Town of Breckenridge
Planning Commission Agenda
Tuesday, April 21, 2009
Breckenridge Council Chambers
150 Ski Hill Road

PLANNING COMMISSION MEETING

Planning Commission Staff Report

A-3.0
 SHEET NUMBER
 OF 1

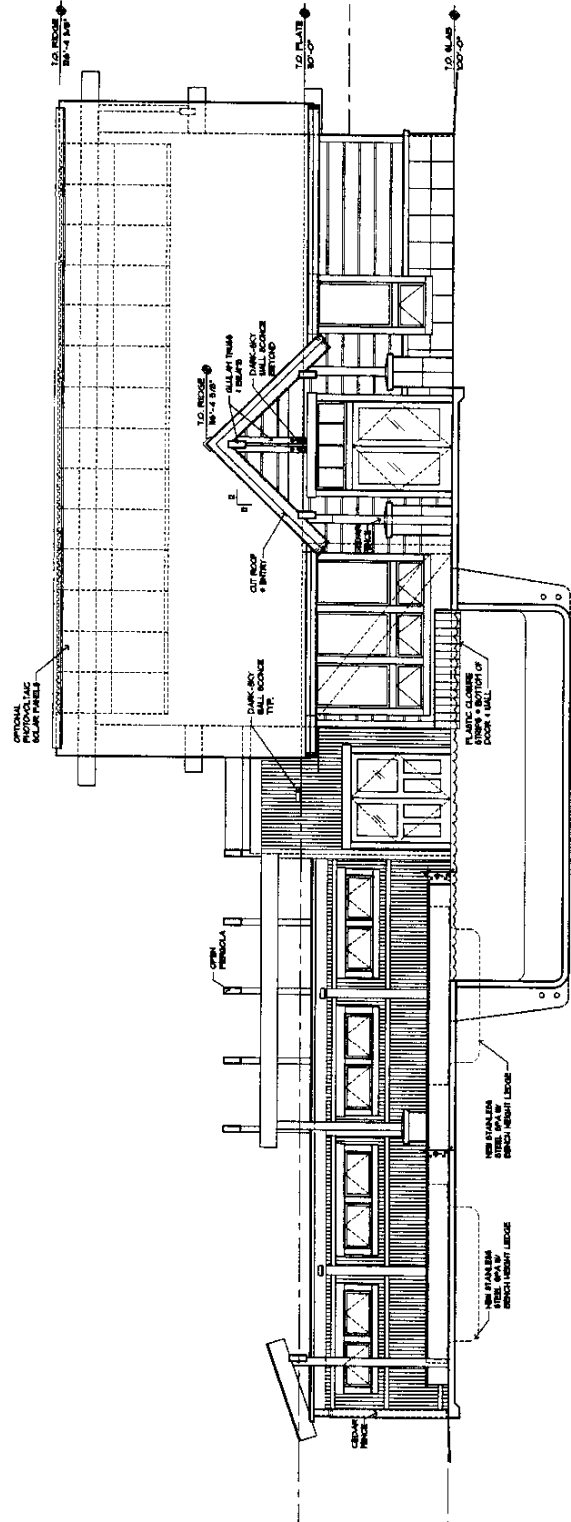
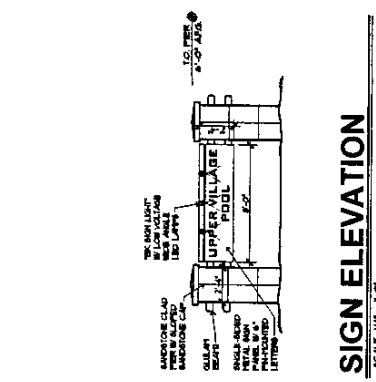
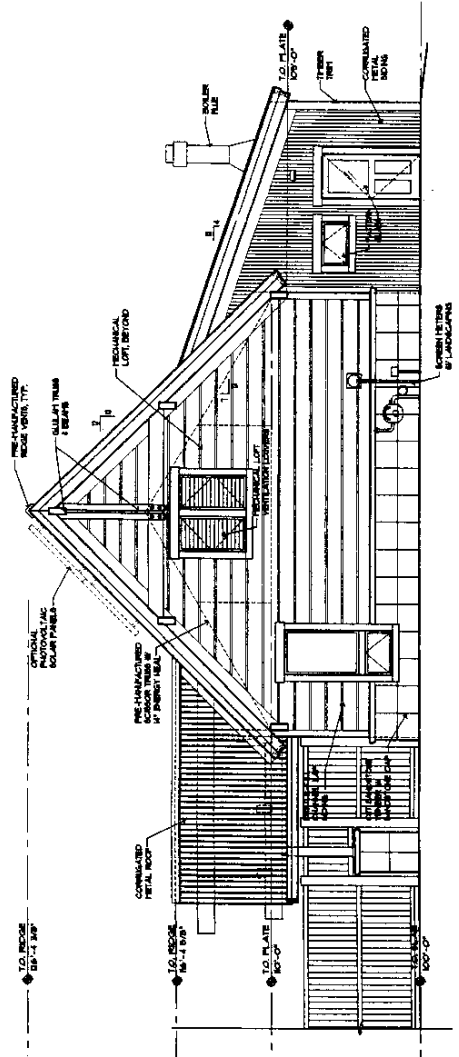
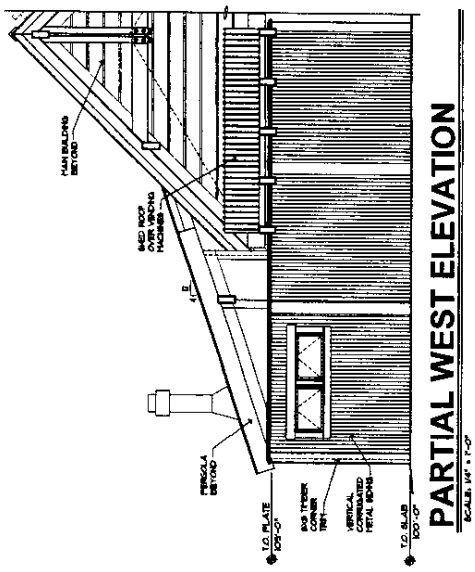
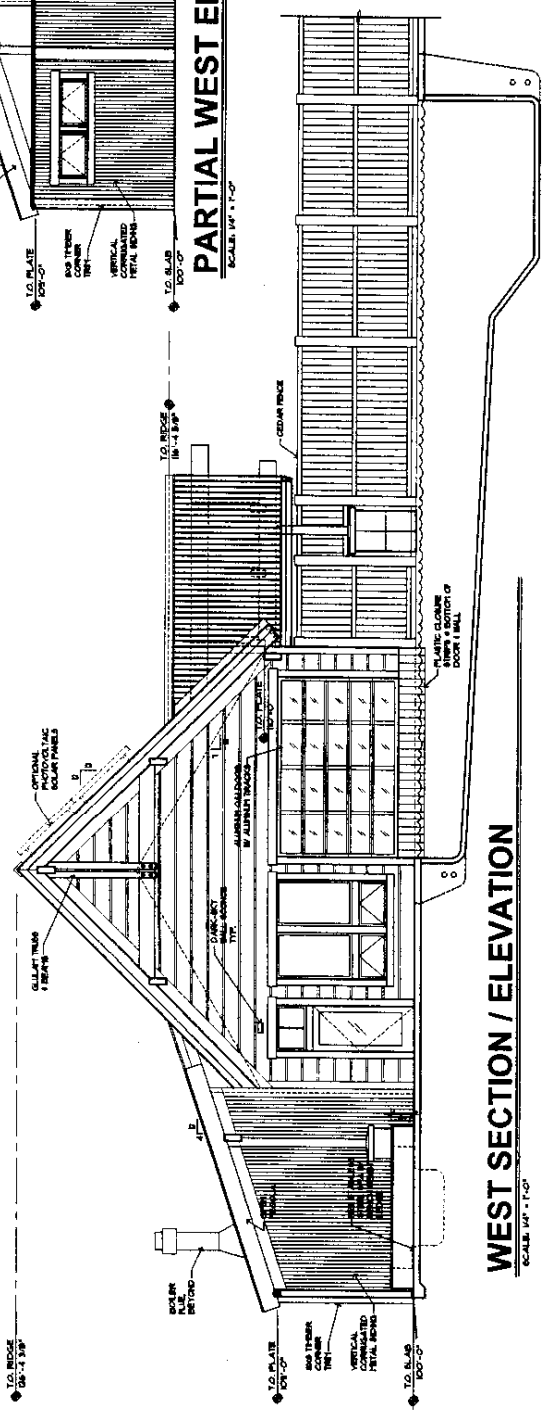
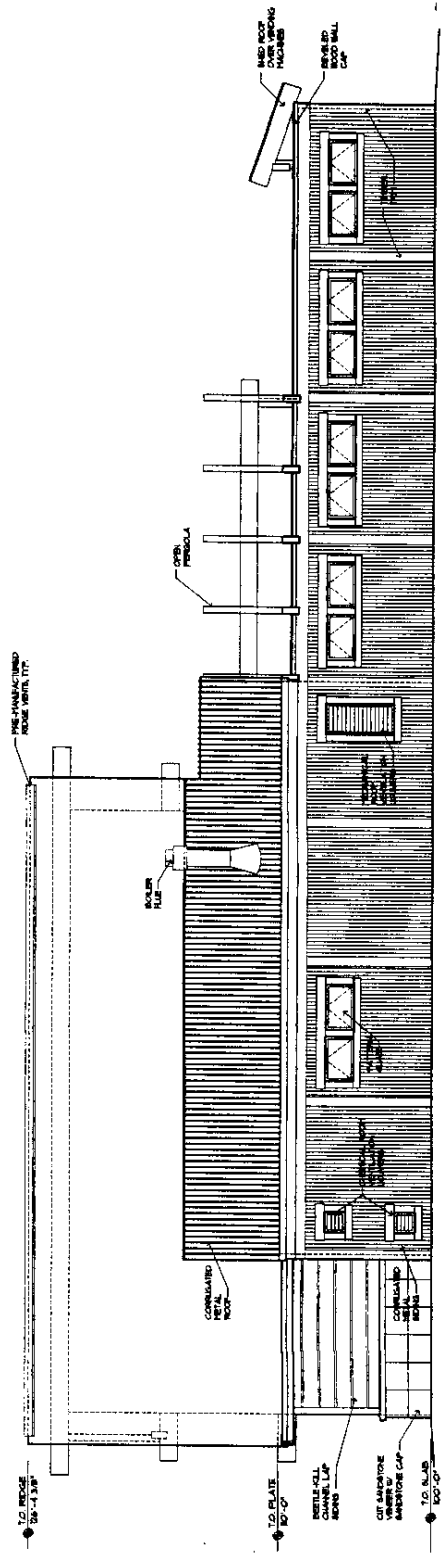
Proposal: The applicant is proposing to remodel the Upper Village pool. They are proposing to demolish the existing 940 sq. ft. pool building, and then build a new 1,698 sq. ft. pool building. The new pool building will include: a check-in desk, enclose an existing spa, build a swim-under overhead door, locker rooms, and a mechanical room. Two new 12' x 8' stainless steel spas are proposed. A new insulated pool cover would be installed as part of the remodel. Applicant proposes to remove paving as required, provide new base and paving at new parking areas. The new pool building would be sided with beetle-kill channel lap siding and corrugated metal siding. Asphalt shingles and corrugated metal roofing are proposed. Optional photovoltaic solar panels are drawn on the plans. Cut sandstone veneer with sandstone caps are proposed for the base of the new pool building. A color rendering of the proposed building will be available for review at the meeting.

Site Plan: The site plan only changes slightly with the pool house moving to the northeast. Staff has no concerns with the site plan.

Snow Removal And Storage (13/R): The parking area is approximately 5,568 sq. ft. x 25% = 1,392 sq. ft. of snow storage is required. The applicant is showing at least 1,670 sq. ft. of snow storage on the plans. Staff feels there is more than enough room for snow storage.

Parking (18/A & 18/R): 17 parking spaces are shown on the site plan (including one accessible parking spot). Per the original Staff report 7 spaces were required (two parking spaces per 1,000 sq. ft. of gross floor area. The pool house, pool and decks comprised approximately 3,500 sq. ft., therefore seven spaces could easily be placed on the lot. In the past the parking lot was not striped, which did not lead to efficient use of the parking lot. With this proposal the lot would be striped, and hence parking would fit more efficiently.

Landscaping (22/A & 22/R): 4 new spruce trees and 12 new aspen trees are proposed with this application. Also, 36 new shrubs and new perennials are proposed. Staff supports the proposed landscape plan.

DATE: 1/20/2020
 DRAWN BY: M. HORN
 CHECKED BY: M. HORN
 PROJECT: 177 DISCOVERY HILL DRIVE
 SHEET: A-1.2

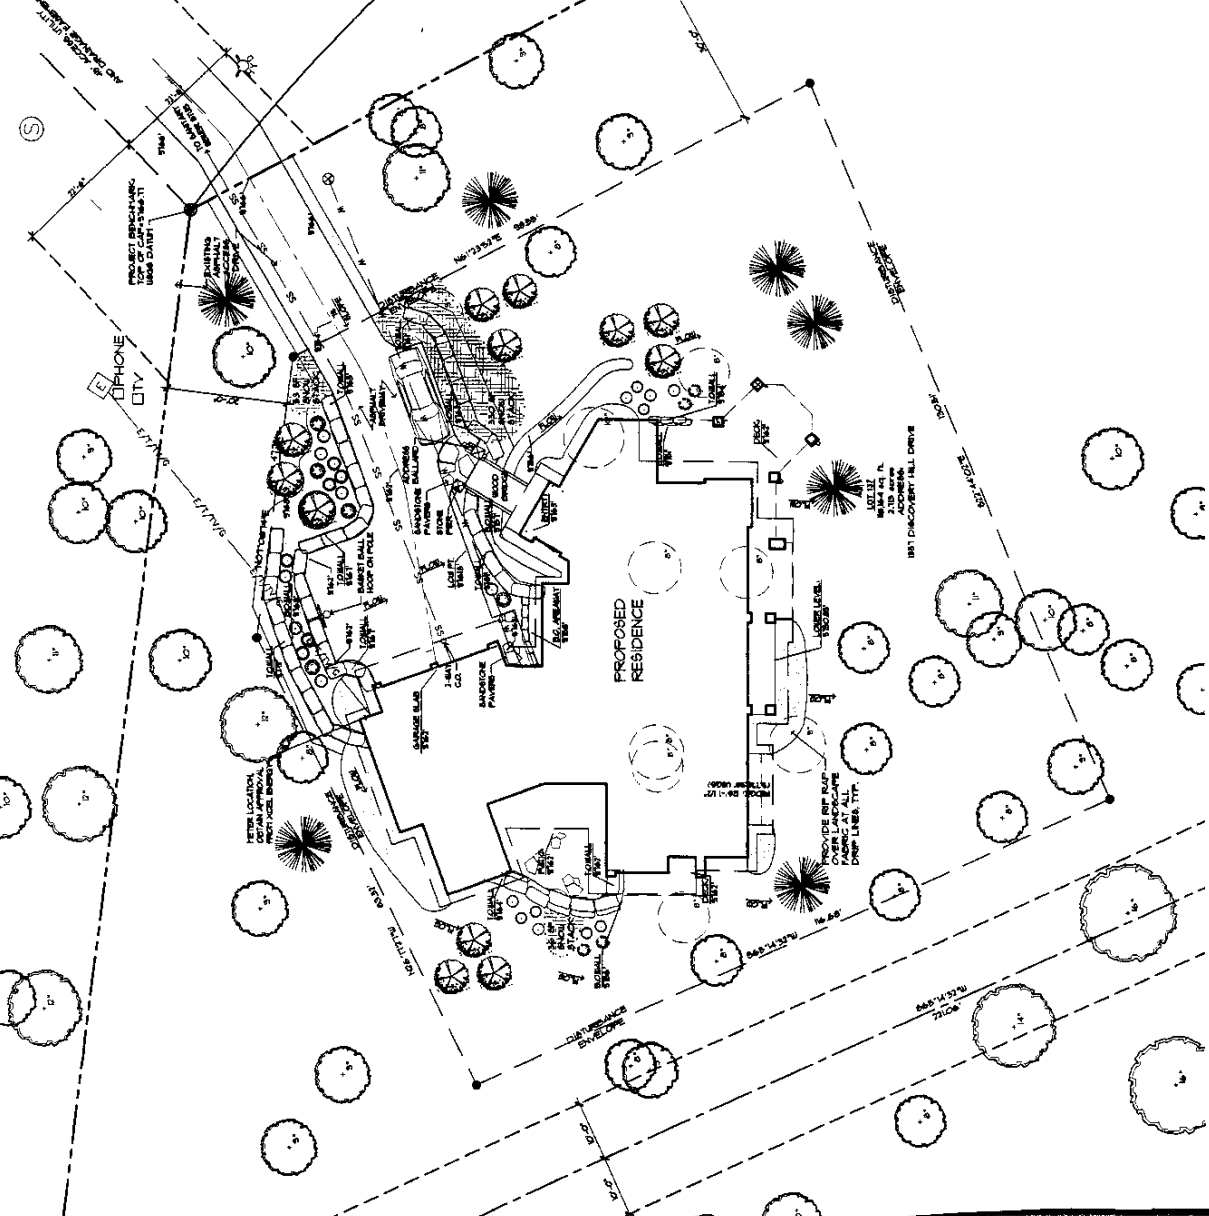
Planting Type	Quantity	Size
Spruce trees	7	(5) 6' to 8', (2) 8' to 10'
Aspen	12	2" to 3" min. caliper at least 50% multi-stem
Potentilla	9	5 gallon
Alpine Currant	12	5 gallon
Peking Cotoneaster	13	5 gallon

SALT CREEK SALOON ROOF LAYOUT- 15- 4' X 8' COLLECTORS
 3 ARRAYS OF 5 PANELS FLUSH MOUNTED

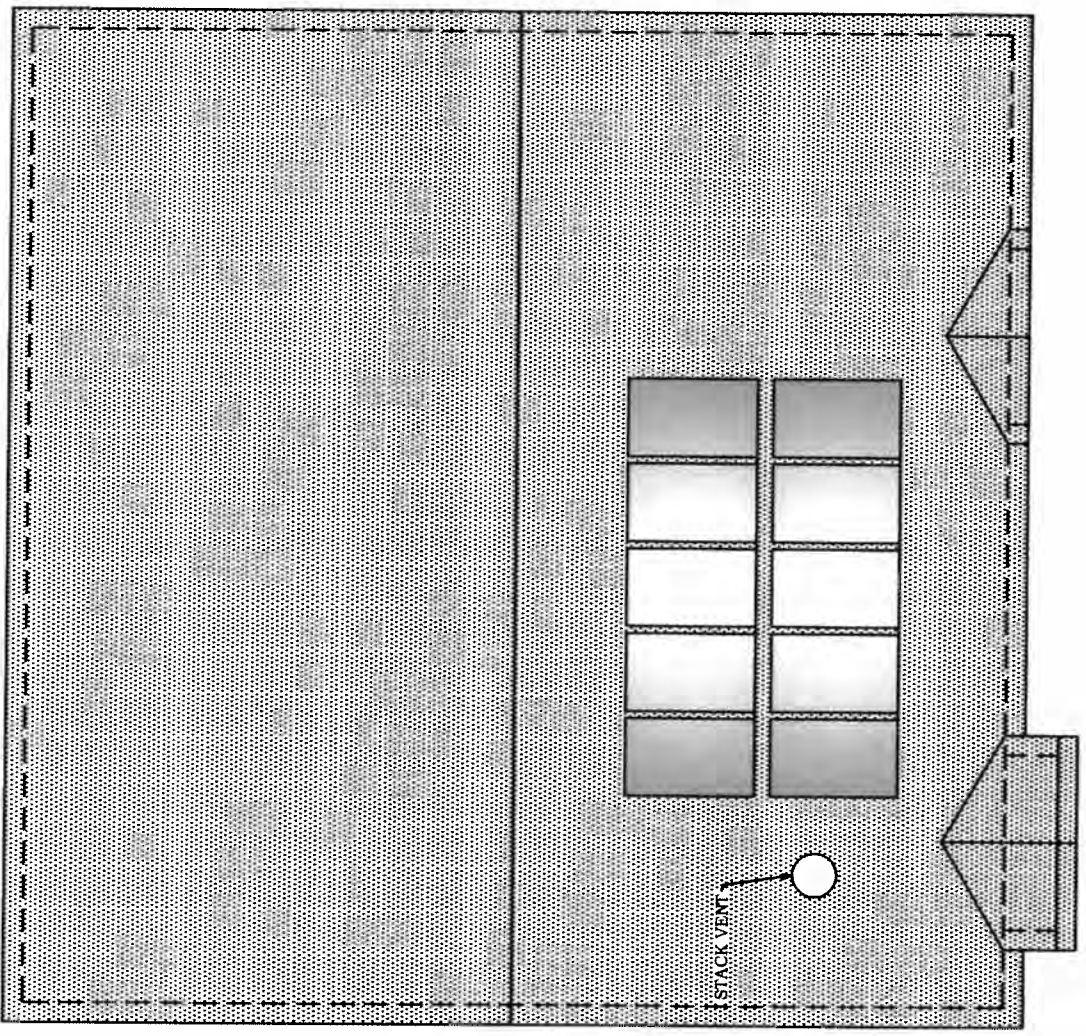
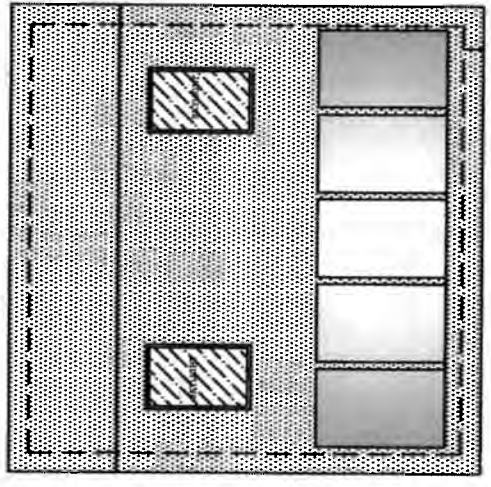
Proposal: The applicant is proposing to install a 30 kilowatt solar thermal panel system on the west southwest facing roof on the primary building as well as on the shed at the rear of the property. This array will be mounted parallel to the roof surface with 9" maximum of clearance between the array and the roof. This array is not highly visible from Lincoln or Main Street. Please see roof layout drawing for array dimensions.

The system will consist of solar collectors flush mounted on the West Southwest roof of the restaurant and on the roof of the outbuilding to the rear of the restaurant. Positioning of the collectors will minimize visibility from Lincoln and Main Streets. The heat from the collectors will heat a solar tank within the basement of the building and the heat would then be transferred to the restaurant hot water system by way of a heat exchanger. The existing restaurant hot water system will remain in place to provide final hot water

The front of the Salt Creek Saloon faces approximately 155 degrees true – or South Southeast. The Town of Breckenridge requests flush mounting for solar collectors (parallel to the roof slope). As a result, the approximately 4 pitch (or about 18 degree slope) roofs on the West Southwest side of the restaurant and the out-building in the rear provide the best solar collector locations that meet Town guidelines. Collectors placed on these roofs will generate approximately 85% of the optimum solar potential that could be provided by collectors that are facing directly south.

West Southwest Roof of Out Building at Rear of restaurant. An array of 5 collectors will be flush mounted below the skylights seen in this picture.
